Cottam - Sturton by Stow Parish Council

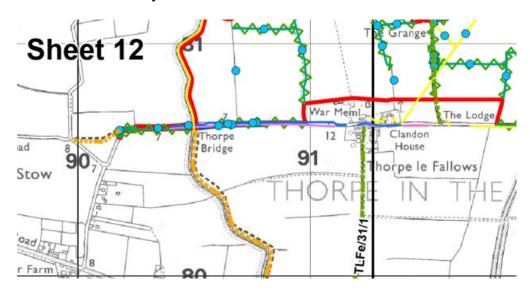
The above map shows blue dots, which when the map legend is consulted say "object within array". Clearly the blue dots along Thorpe Lane are not within any array.

Object 1154 is a footpath sign?

Object 1155 does not signify apart from it's the middle of the road?

Object 1156 main drain outfall?

Case in point – there is no need for access roads between fields at this point since the fields each side of Thorpe Lane (western side of Thorpe Bridge) are not within the boundary of the project. Therefore, the question still stands; Why is this particular piece of road subject to being within the boundary of the dDCO?
